**Stony Fork Restoration Site
Upper Neuse River Basin - 03020201
Monitoring Year 03
DMS Contract 6830**

**DMS Project Number 97085
DWR #: 2016-0372
USACE Action ID: 2016-00875
Johnston County, North Carolina**

MEMORANDUM

Date: January 27, 2022
To: Lindsay Crocker, DMS Project Manager
From: Tim Morris, Project Manager
KCI Associates of North Carolina, PA
Subject: MY-03 Monitoring Report Comments
Stony Fork DMS #6830, Contract 006830
Neuse River Basin CU 030202018
Johnston County, North Carolina

River Basin:	Neuse River
Site:	Stony Fork
XS ID	XS10
Drainage Area (sq mi):	0.04
Date:	7/26/2021
Field Crew:	T. Seelinger/A. Gutierrez

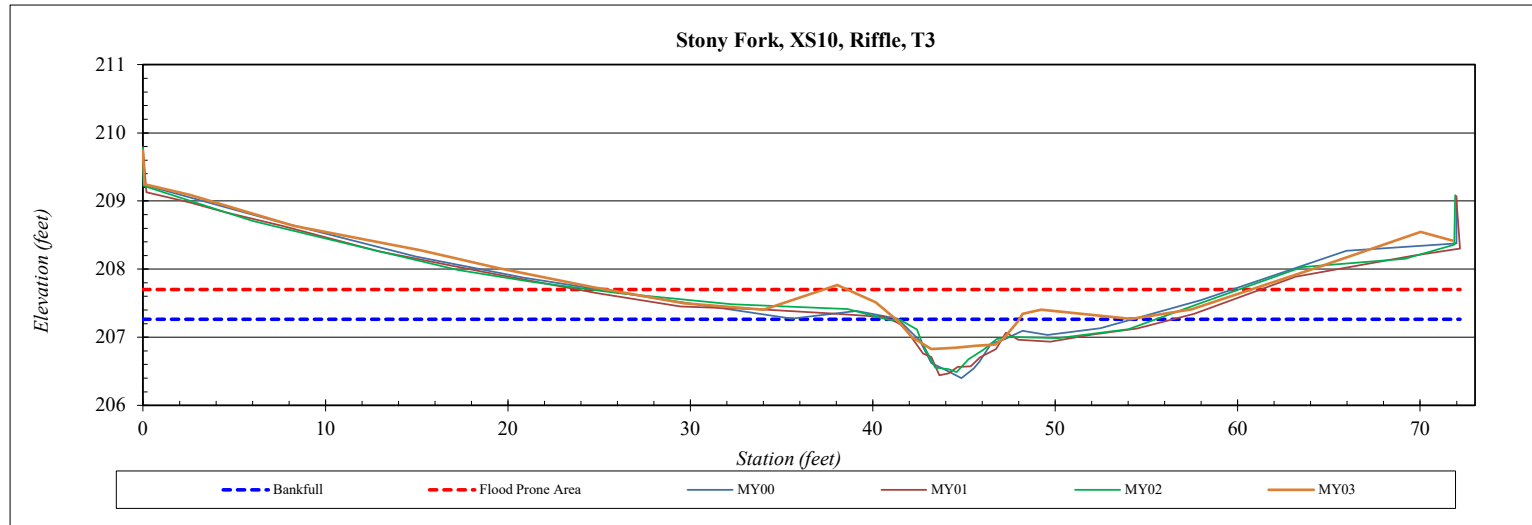
5. Check XS10 BHR to confirm the number is correct (aggradation typically shows a BHR < 1).
KCI Response: Aggradation typically results in BHR < 1 but because in this case both the stream bed and banks aggraded it resulted in a BHR of 1.2 (bank height= 0.52, bankfull max depth=0.44).
